Supplementary Report - Appeal Concerning a First Party Signage Master Plan for 164 Evans Avenue

Date: March 25, 2019

To: Sign Variance Committee

From: Supervisor, Tax, Variance & Permits, Sign By-law Unit, Toronto Building

VIEW LOOKING SOUTH FROM ON-RAMP TO
GARDINER EXPRESSWAY

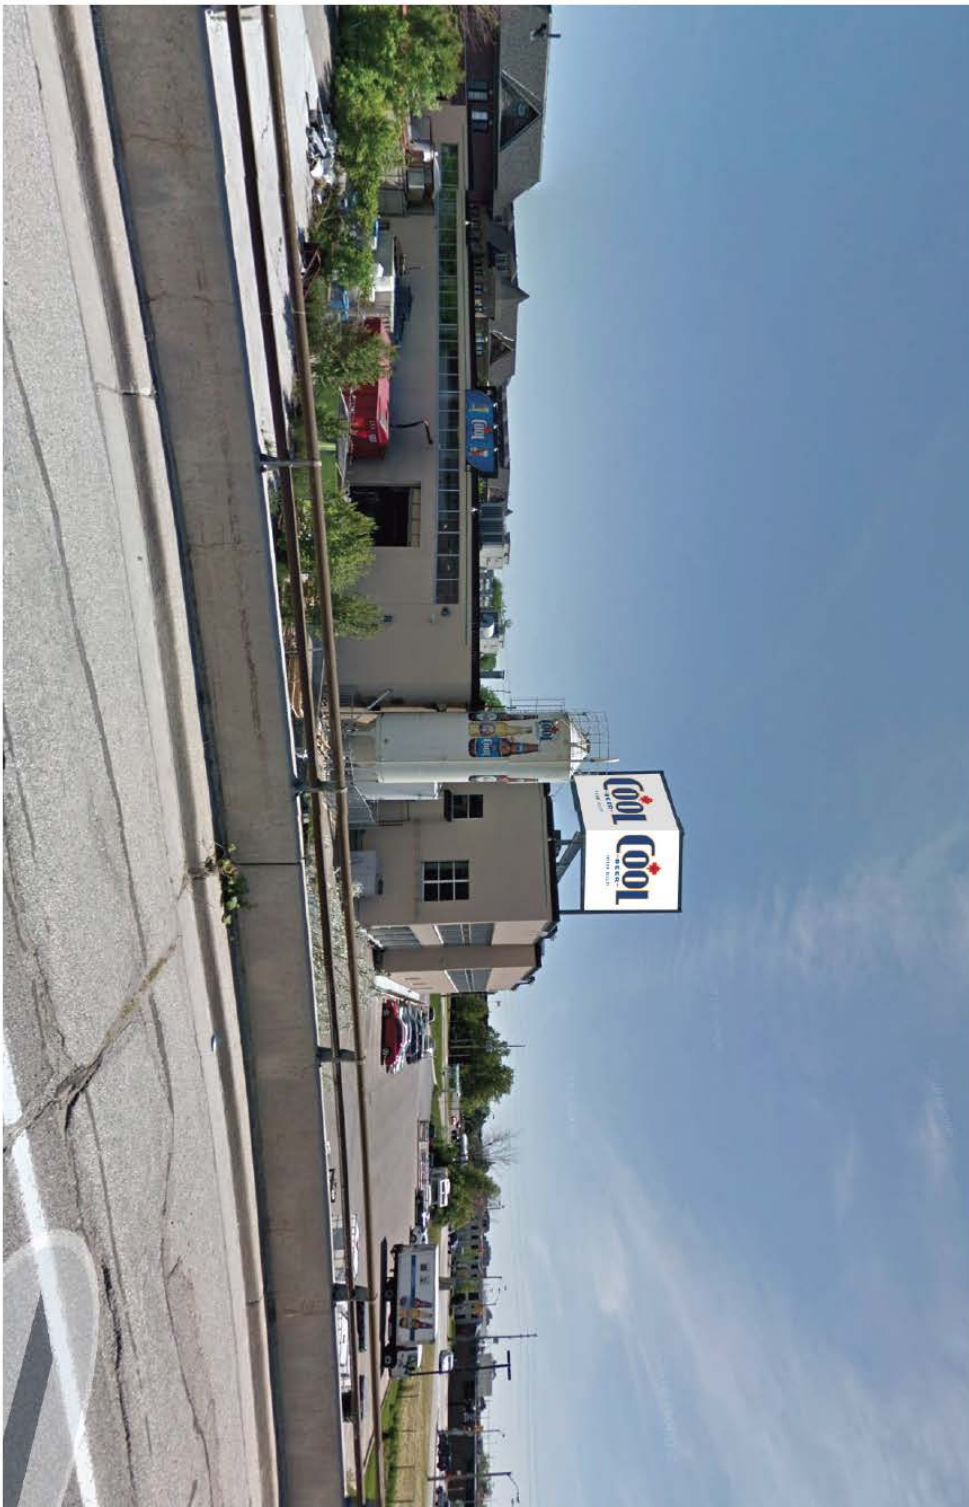
The applicant states in their submission materials that the Proposed Sign will "be designed in a manner that blends well with the existing rooftop as well as the exterior tank structures on the site." Staff disagree with this statement.

Figure 3 below shows a screen capture from Google Streetview in October 2018, with the existing sign structure located above the newer addition to the brewery. This image clearly demonstrates the difficulty of integrating a roof sign into the overall design and architecture of a building. Staff disagree with the applicant's suggestion that the Proposed Sign would "blend well" with the exterior tank structures.
